WISCONSIN PROFESSIONAL BASEBALL PARK DISTRICT

REQUEST FOR PROPOSALS FOR FIELD LEVEL RESTROOMS

Response to Questions – Final

Date: September 30, 2026

1 OVERALL POWER PLAN - FOR REFERENCE
SCALE: 1/32" = 1'-0"

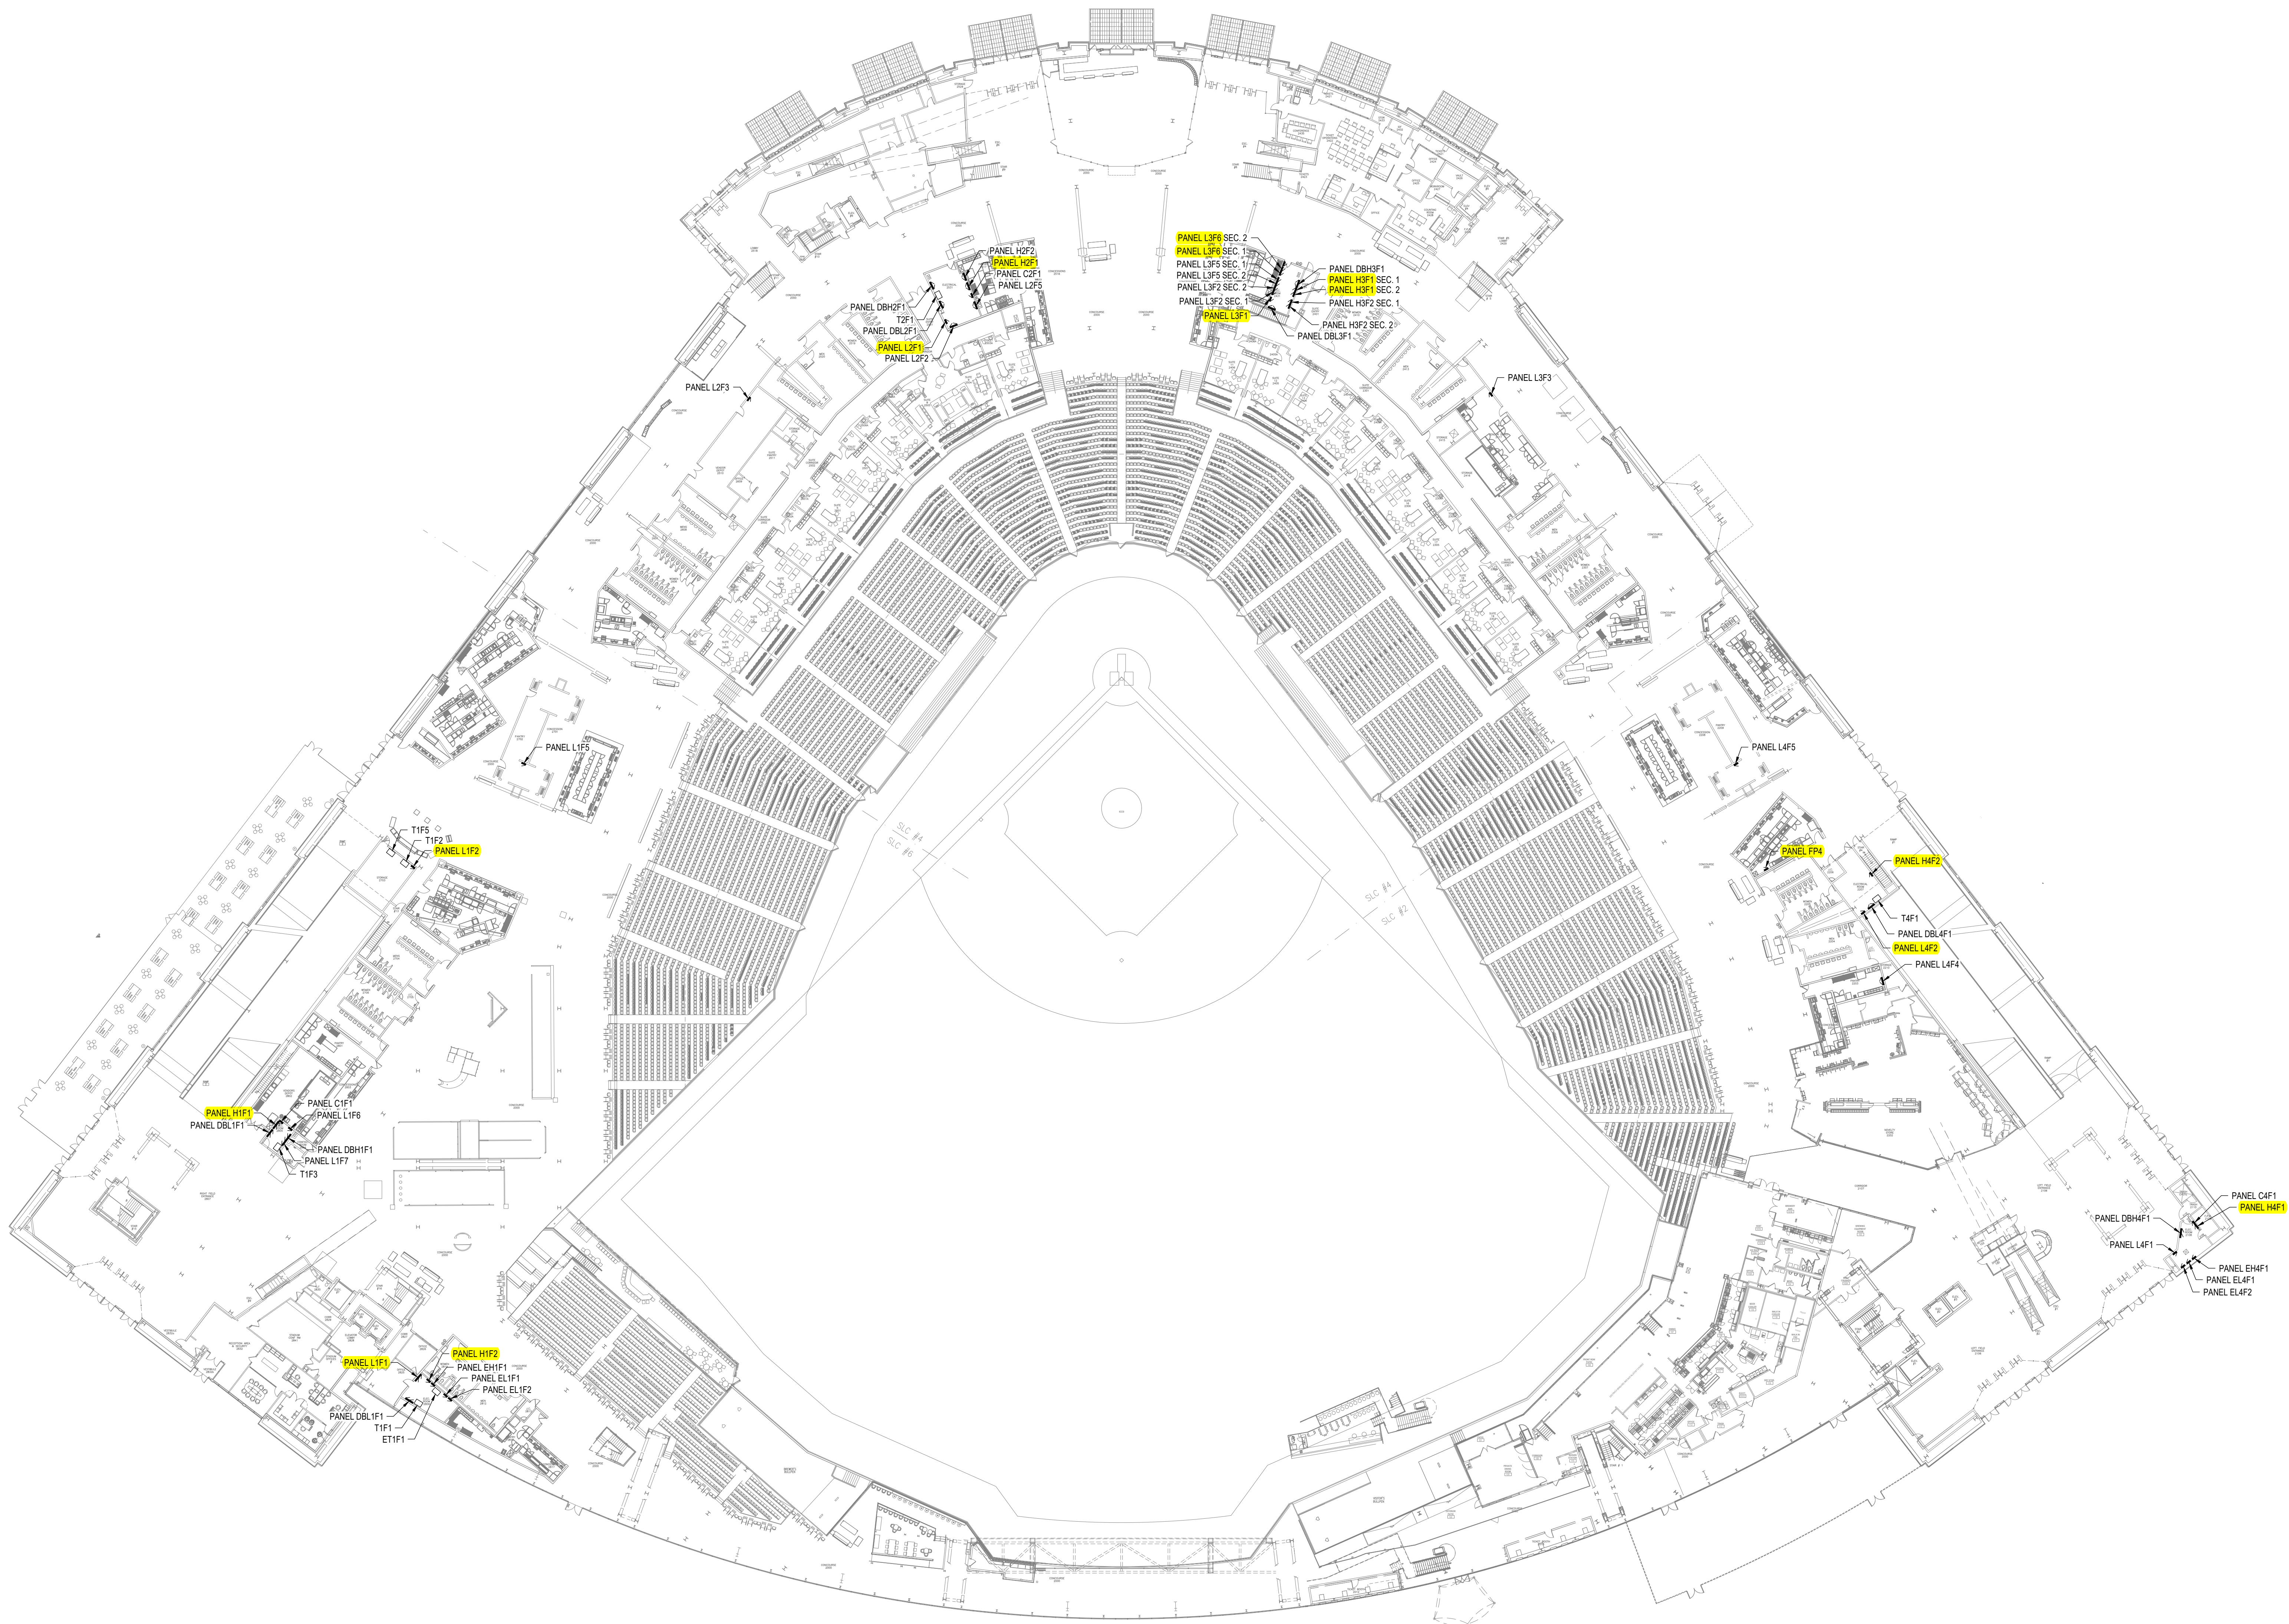
#	Question	Answer
1	I noticed on the site visit and reviewing the drawings there will be added partitions to the urinal walls. It is a code requirement that from center of a drain for a fixture to a wall it's a minimum of 15". Adding these partitions will have a direct effect on the waste and water connections. Every Urinal will have to be relocated to accommodate this, which is a direct contradiction to plan. Please let me know how this will be addressed.	The project scope will not include relocating urinals. Provide pricing for urinal screens and installation as currently drawn for consideration.
2	<u>Add Alternate #3:</u> provide surface mounted junction box for Dyson air blade hand dryer and LFMC whip into side of dryer for surface mount application. For Alt. #3- hand dryers, can you ask if we are piping back to the panels for these or is the circuit already there? If we must pipe back, I will need to know where the panels are in relation to the hand dryer locations.	The hand dryer circuit shall be a new dedicated GFCI circuit. See attached reference plan for panel locations on plan.
